# **Amendment Application for the Proposed Kokerboom 2 Wind Energy Facility in the Northern Cape Province**

## **Final Amendment Report**

Date: April 2019

*DEA Ref:14/12/16/3/3/2/986/AM3*

Figure 2: Proposed optimised (amended) layout for Kokerboom 2 Wind Farm and associated infrastructure superimposed over mapped environmental sensitivities

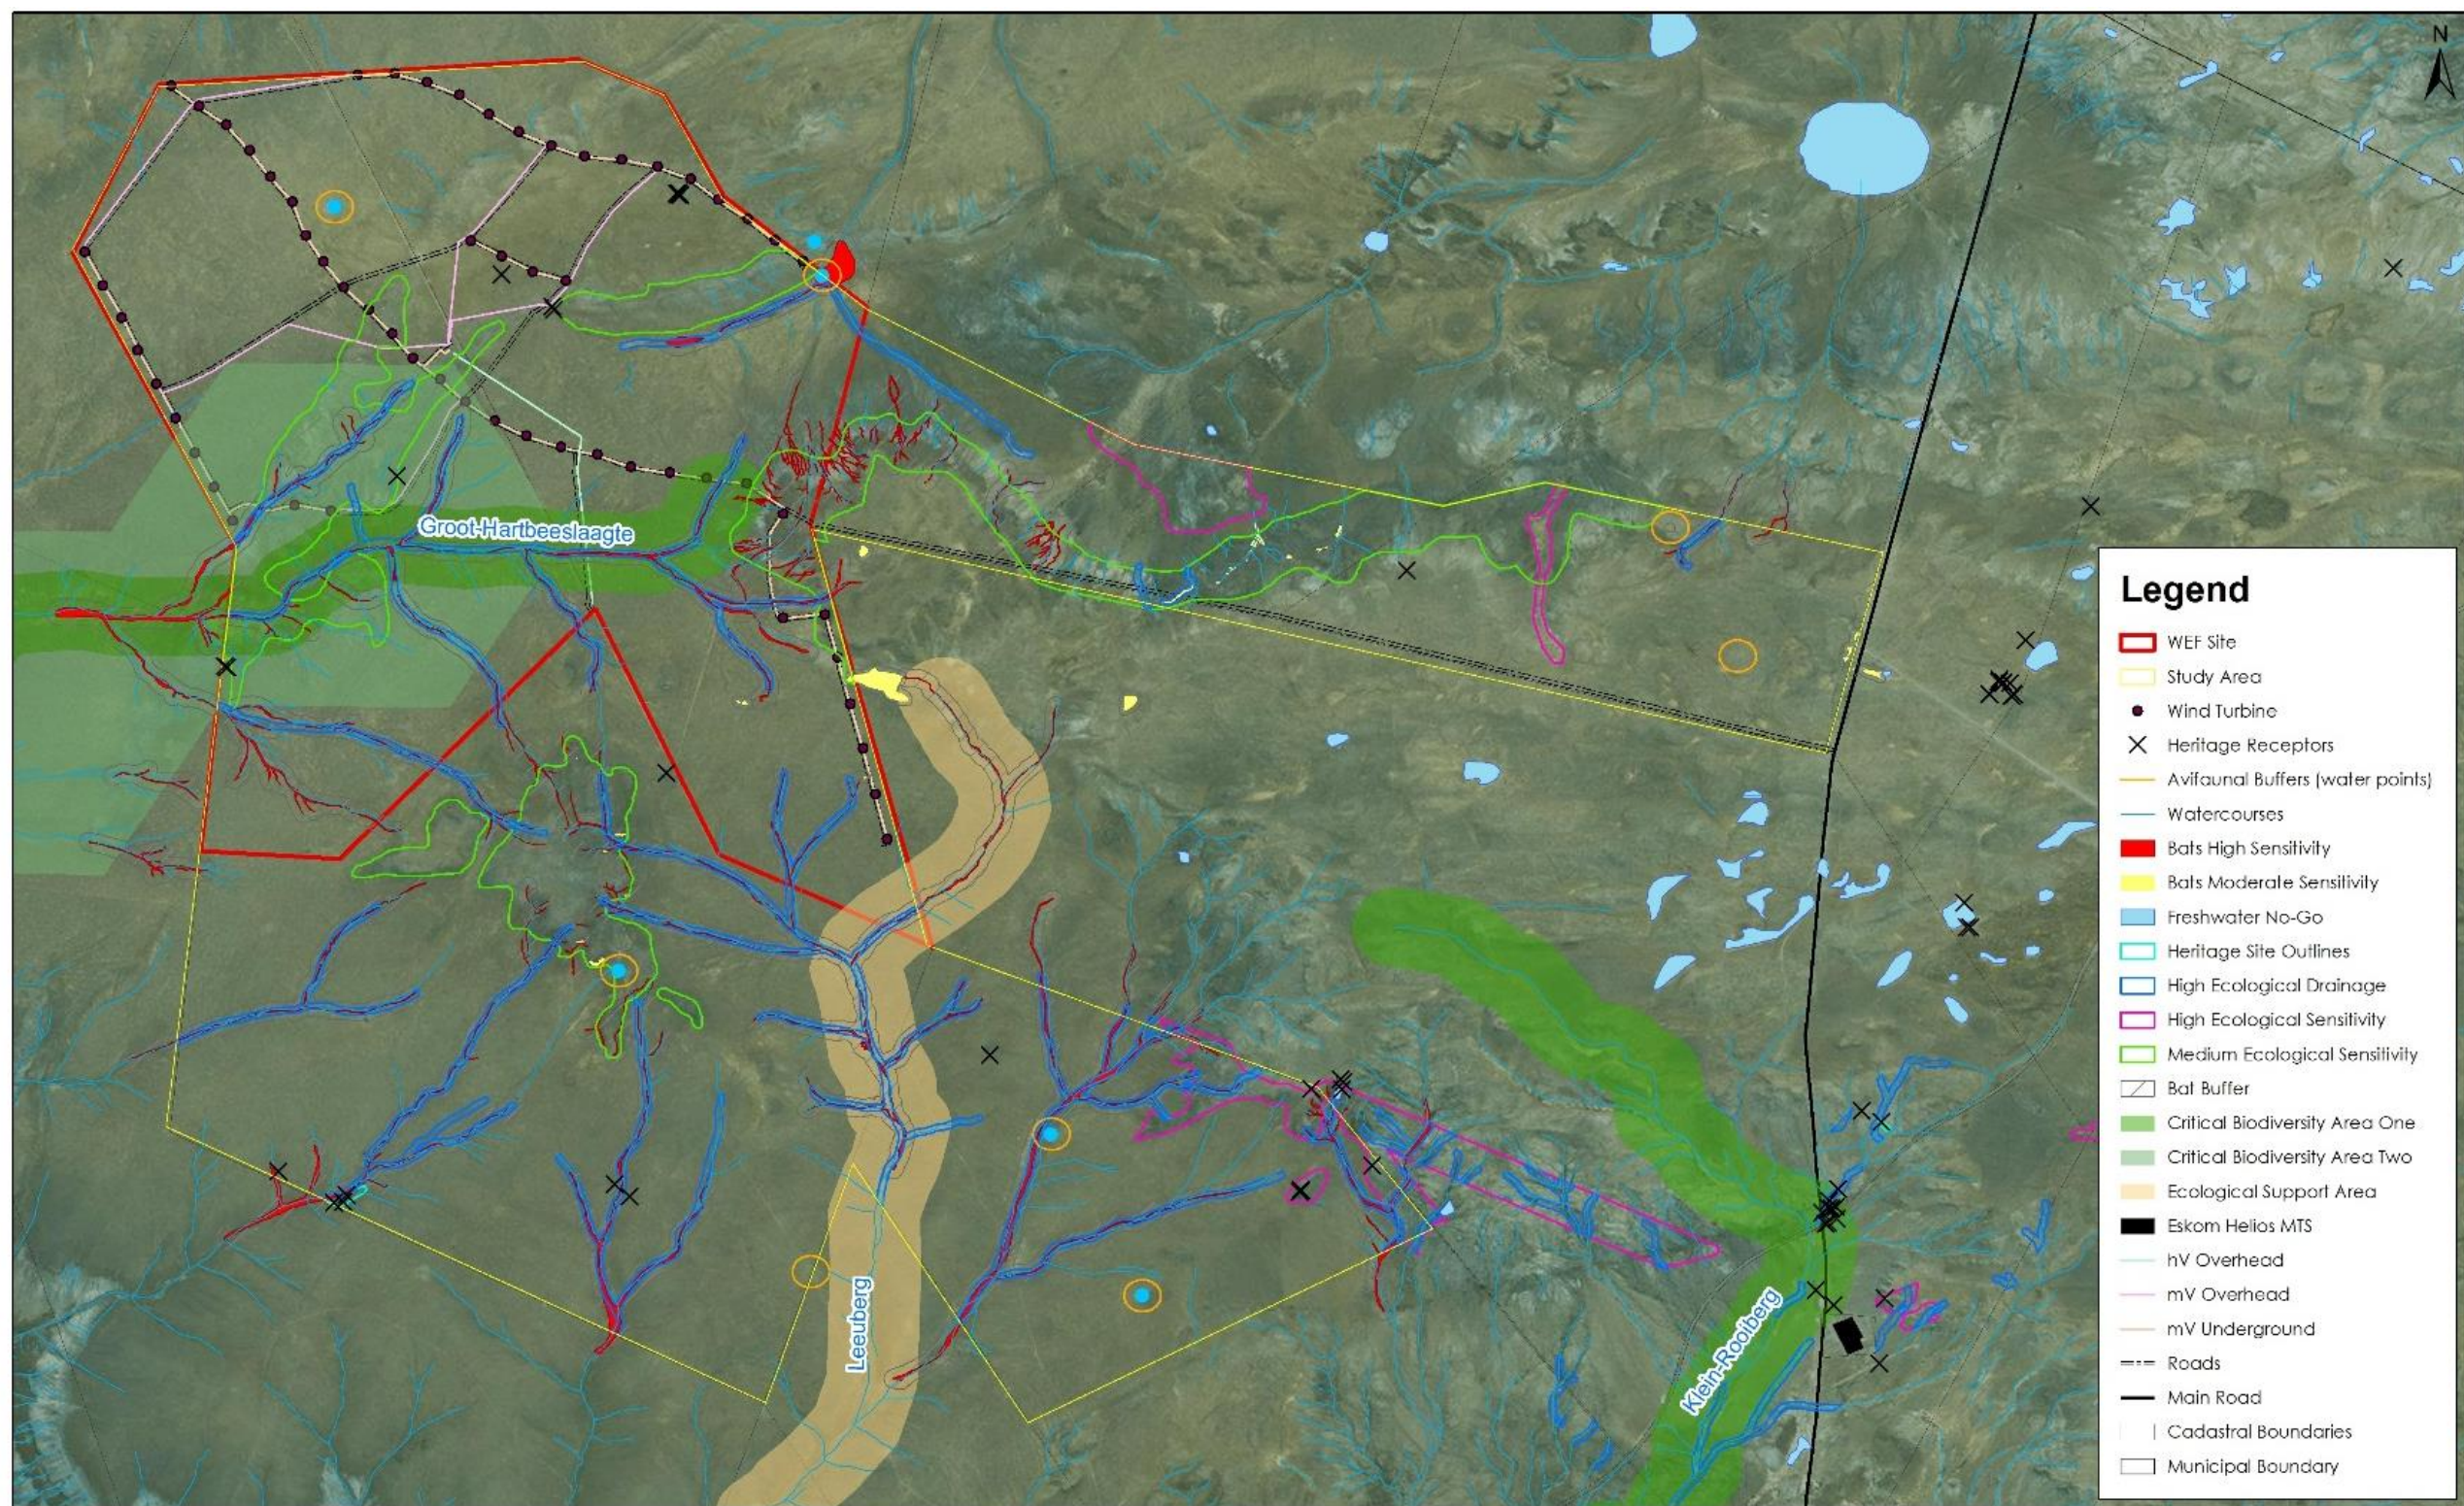
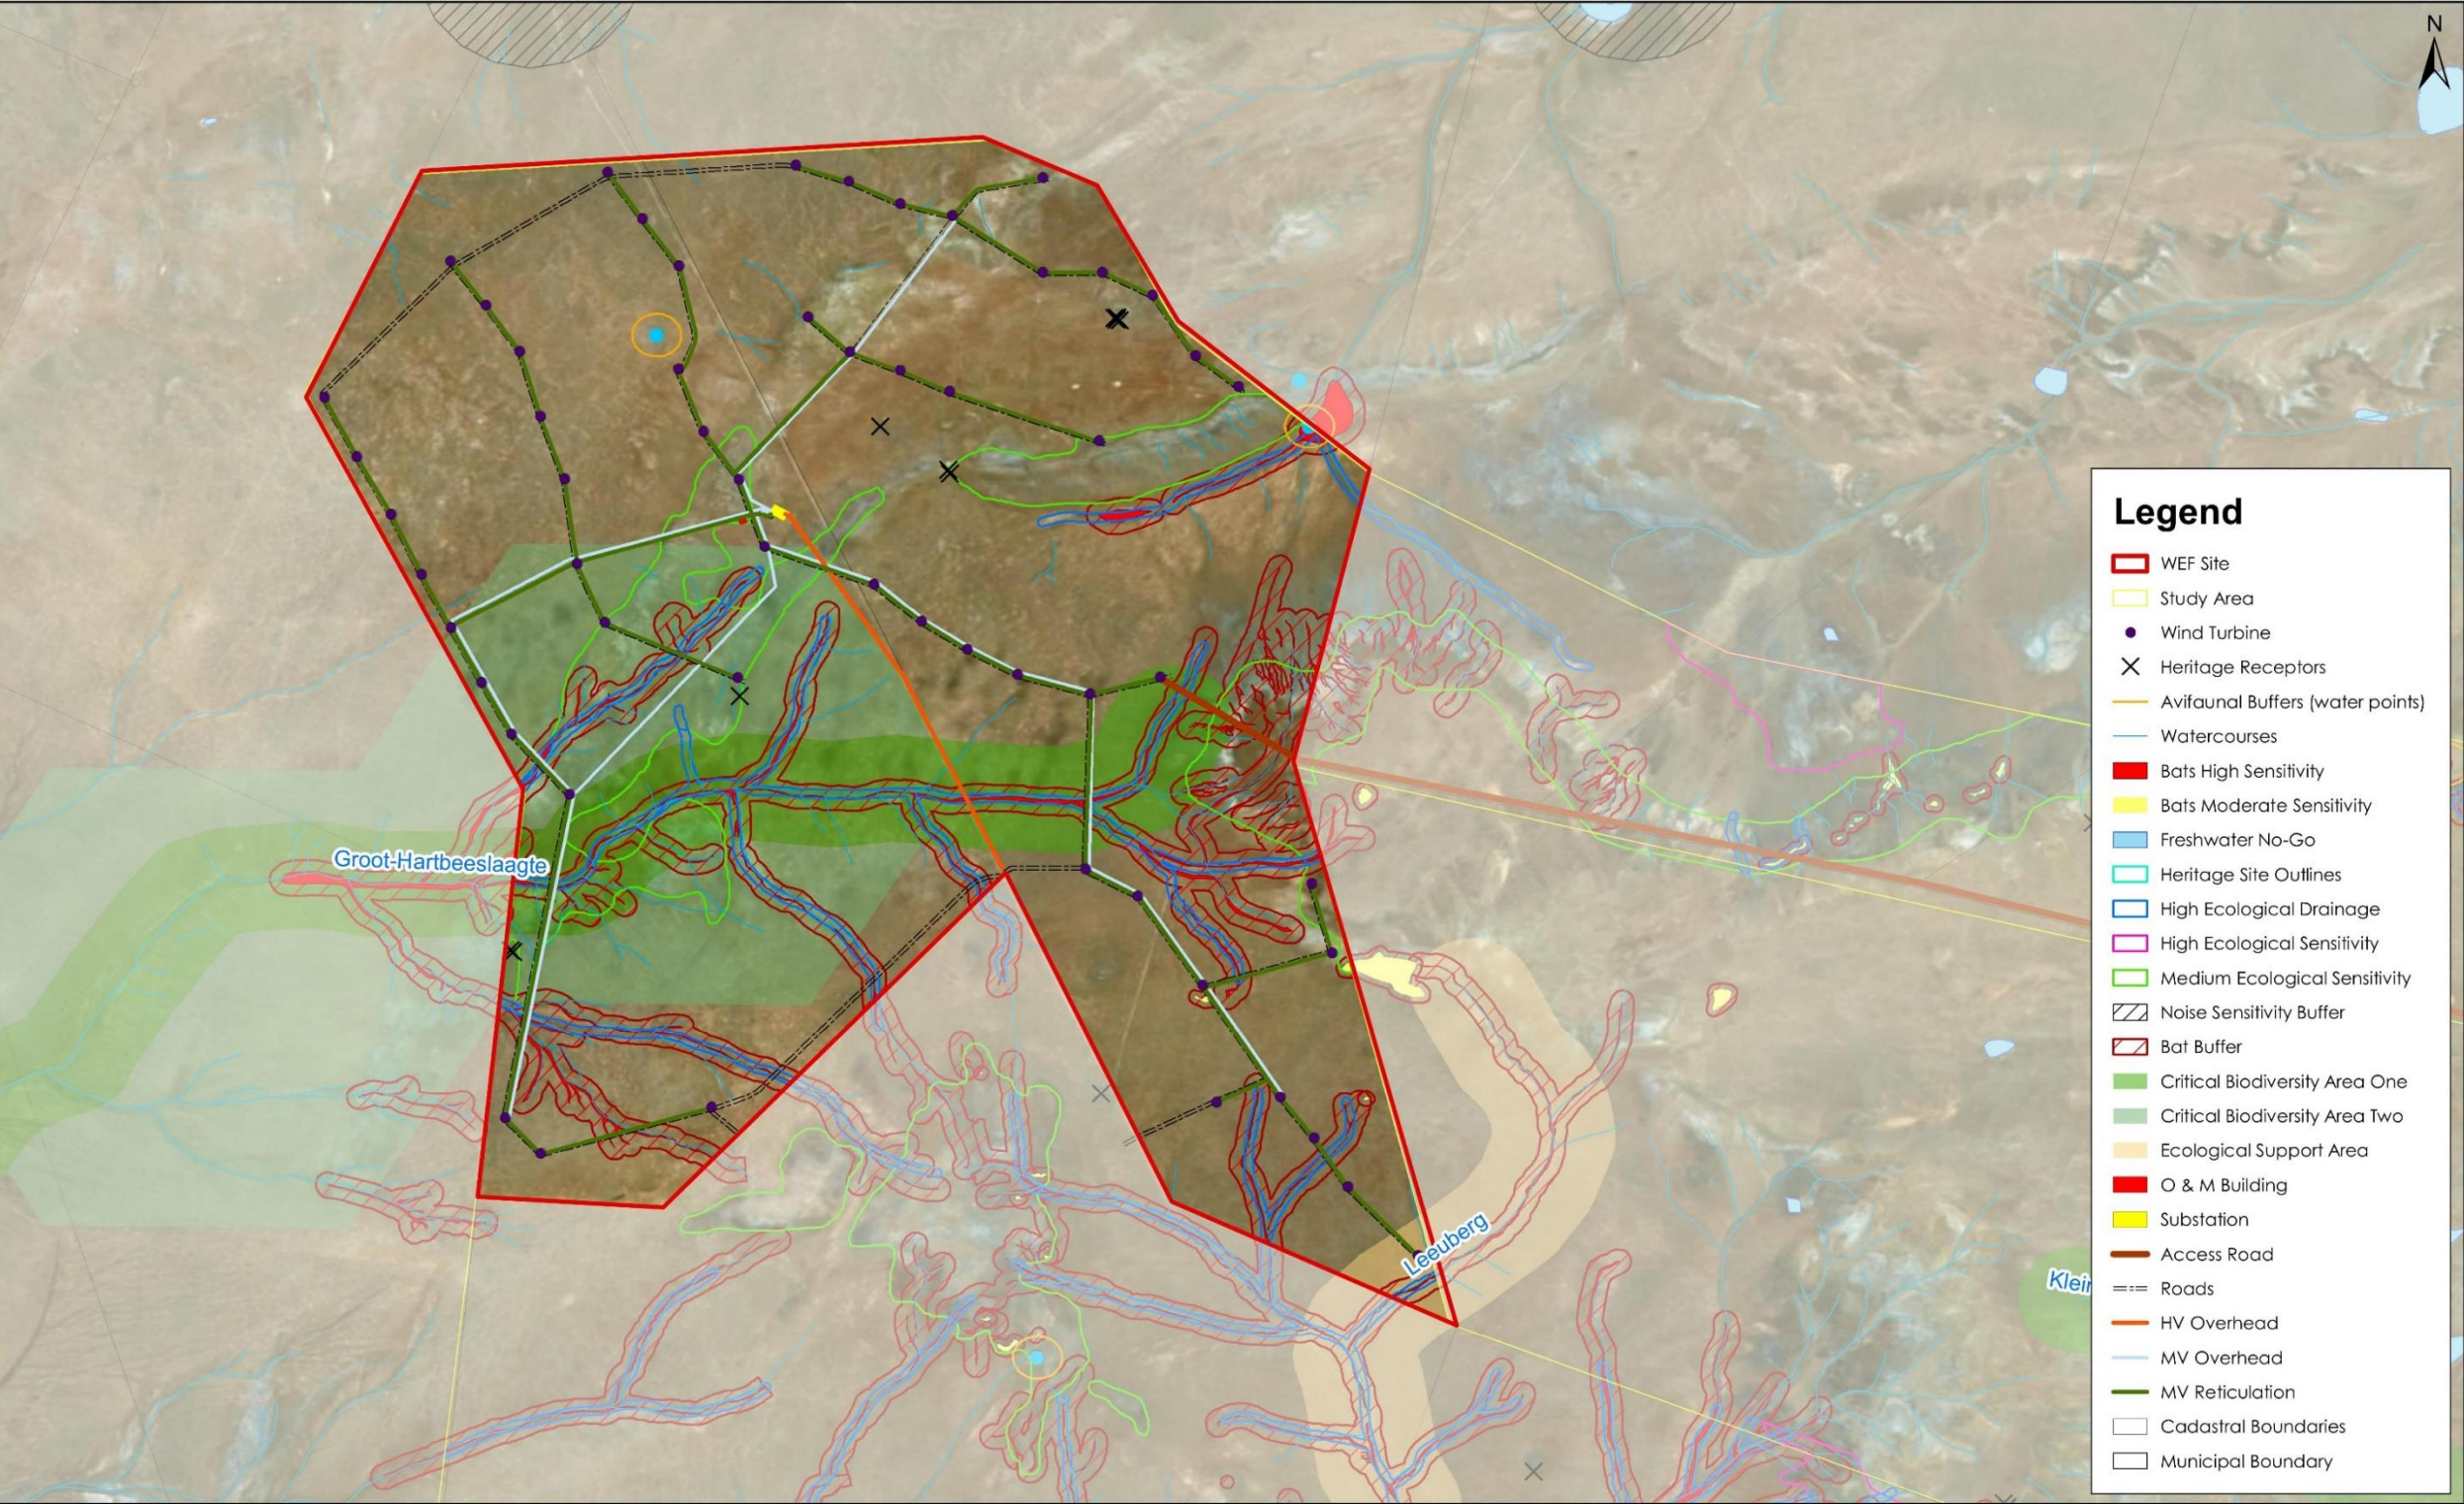
In order to cater for the larger turbine specifications, it is necessary to revise the site layout plan to provide sufficient spacing between the larger turbines, for safety reasons and to reduce internal wake effects between turbines. The layout of the balance-of-plant infrastructure (i.e. internal roads, cables, substation, hard stands etc.) has been revised and optimised in order to cater for the revised turbine positions. The revised turbine locations and associated balance-of-plant infrastructure are all located within the footprint that was previously assessed in the original EIA.

In addition, a length of overhead high voltage (HV) powerline is required to link the wind farm's substation to the Eskom switching station (the latter forms part of a separate EA) in order to export the electricity generated by the wind farm. Due to the costs associated with the HV powerline, the most direct route between the substation and switching station has been proposed, to minimise the length of the powerline. Keeping the length of the HV line to its current, shorter length is considered desirable to minimise potential avifaunal impacts. As a result, the proposed overhead HV powerline is mostly aligned to the internal road and deviates over a shorter distance as compared to the authorised HV powerline route.<sup>4</sup>

<sup>4</sup> This length of overhead HV powerline was assessed in the original EIA and forms part of the site layout plan that was submitted to DEA with the final EIA Report (Figure 1). However, Condition 58 of the EA stipulates that all cables must follow internal roads. It is now requested that this condition be amended (see Table 4 in order to allow for the overhead HV powerline to deviate from the road network and follow a more direct route to the new onsite substation location as shown in Figure 2.
